( US 7G3 )

Additional support of the elevator push rod at bulkhead 23

Drawing L - 140.1 - S 13

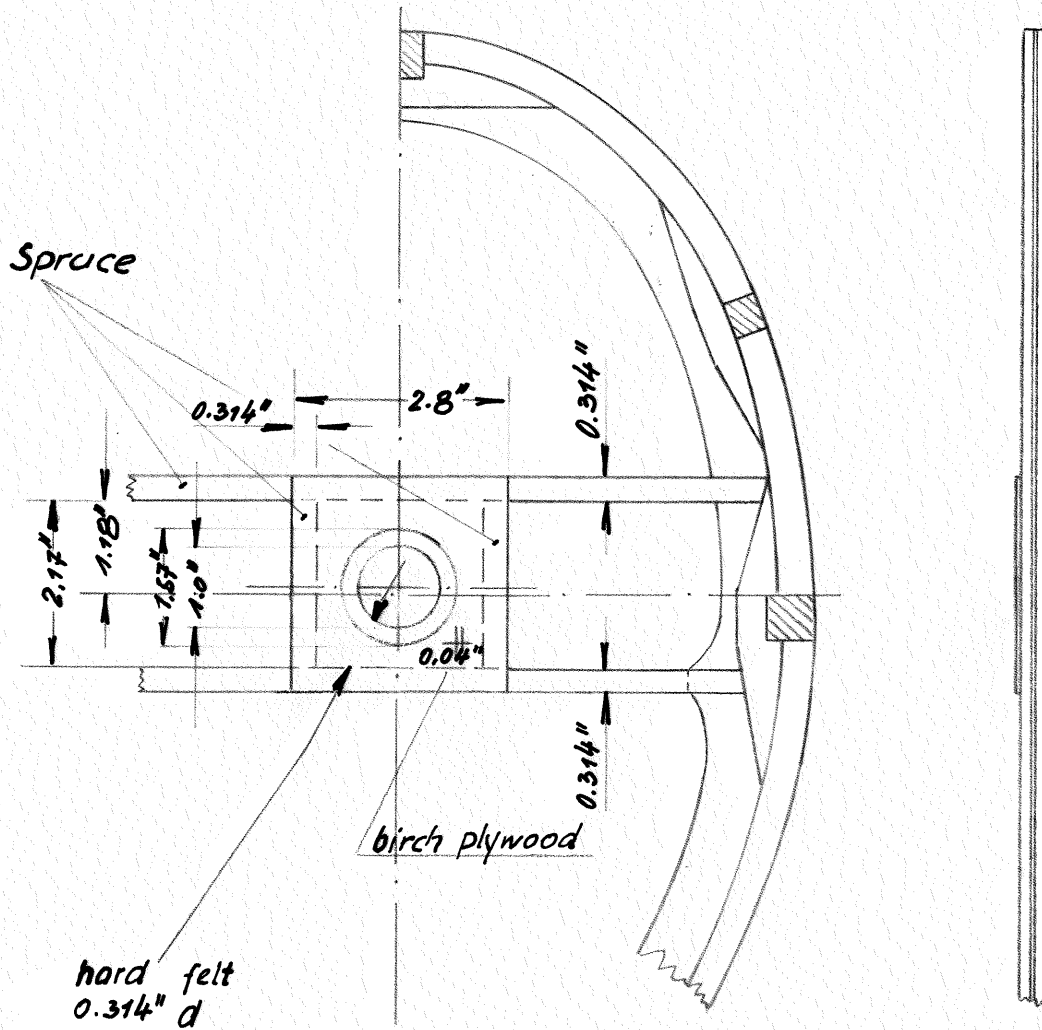
- 1) After modified drawing L - 140, 1 - S 13 to be made at all new gliders.
- 2) Already made from serial number 1134 of the Schleicher production.
- 3) At former S.Nb. the modification is to be made at repairs or overhauls at latest until 1<sup>st</sup> March 1963.  
Excluded are aircraft without automatically connection, in general the version Ka 2.
- 4) Parts are to be ordered from the Fa. Schleicher.
